Initial Project Review

Preliminary Plat: Calvary

Application Number: 939495

Street Tree Plan

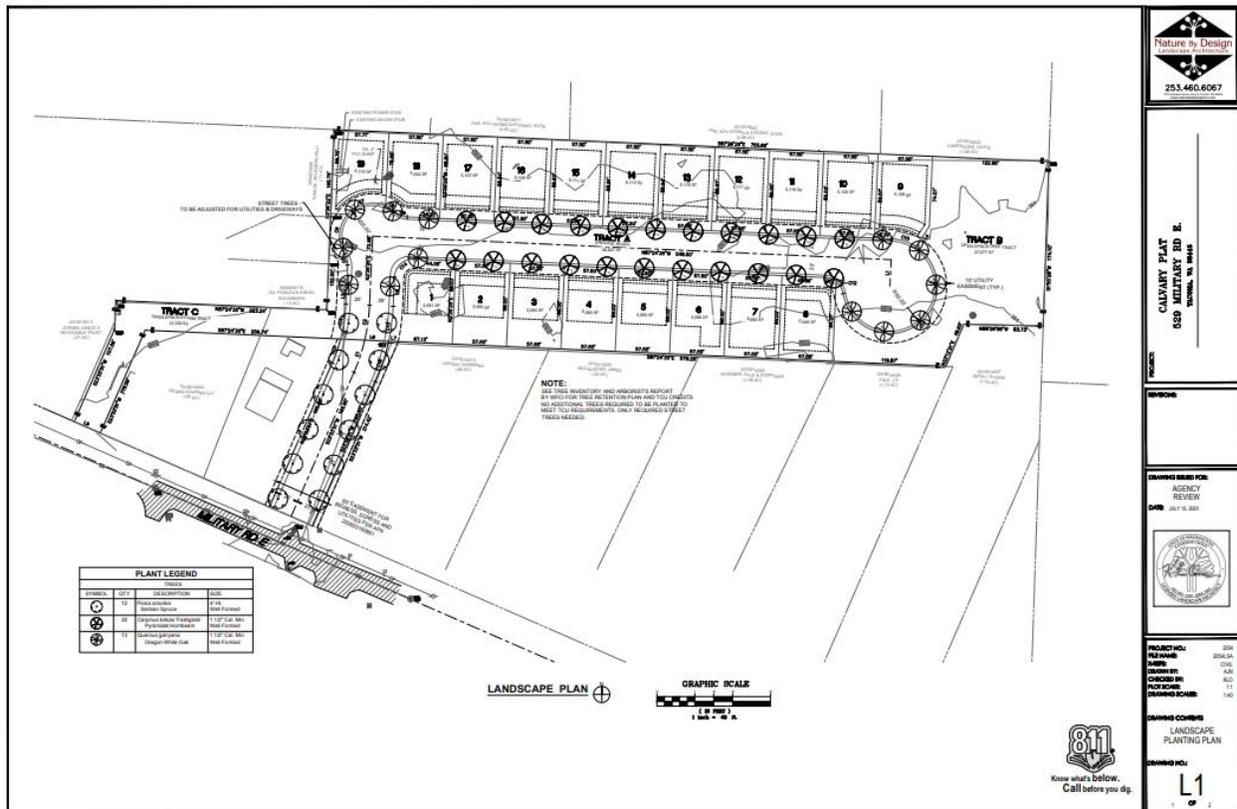
- Landscape Buffers (18J.15.040)
No landscape buffers are required for this project.
- Street Trees (18J.15.050)
Street trees are required to be planted along each side of new streets at a rate of 1 per 30 lineal feet of roadway. The application includes a street tree plan.
